Committee of the Whole Report

Subject: Rezoning Application No. 00714 for 3080, 3082 and 3090 Washington

Avenue and associated Official Community Plan Amendment

Figure 1. Proposed Site Plan

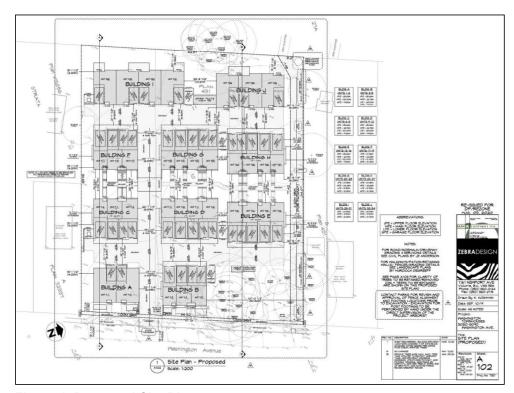
The immediate area is characterized by a mix of single-family dwellings and townhouses that are two and 2.5 storeys in height. While the majority of the buildings proposed are three storeys to minimize impacts on neighbouring properties to the west, the applicant is proposing to locate two-storey attached dwellings (Buildings I and J) at the west end of the site, which is the highest peak of the property (refer to Figure 1 below). A two-storey building (Building A) would also be located on the south-east corner of the site, which would provide a sensitive transition to the neighbouring character home.

There is an approximately one- to two-metre grade change between the subject site and the property to the north, which is creating an abrupt transition between the proposed three-storey attached dwellings and the house to the north, which is significantly lower in height (refer to Figure 2 below). To soften the impacts on neighbours and provide breathing room between the adjacent single-family dwelling to the north, the applicant is proposing to locate an outdoor amenity space on the northeast corner of the site, adjacent to the connector, which results in a building separation distance of approximately 37m between the existing house and proposed attached dwelling (Building B). In addition, to reduce potential privacy concerns and opportunities for overlook, the applicant has proposed minimal windows on the north and south elevations of buildings facing the adjacent neighbours. There would be some shadow impacts from this development on the neighbouring properties regardless of whether the buildings were to be two or three storeys in height.

Notwithstanding these proposed design interventions by the applicant to address the building transition and potential privacy concerns, it is recommended that Buildings C, E, F and H should also be reduced to two-storeys to ensure that the proposal provides for a sensitive transition and fits in with the neighbourhood context. It was suggested to the applicant that they consider partial basements instead of a full third storey, especially given the approximate 5m grade change from the southwest corner to the northwest corner of the site; however, the applicant indicated to staff that this would not be a feasible option from a design and financial perspective.

- 1. Lower the height of buildings C, E, F and H to ensure that there is a sensitive transition to the neighbouring lower density residential buildings on the north and south side of the subject site, to the satisfaction of the Director of Sustainable Planning and Community Development.
- 2. Explore potential design changes to the greenway to see if it is possible to both retain trees and make it wheelchair accessible, to the satisfaction of the Director of Engineering and Public Works.
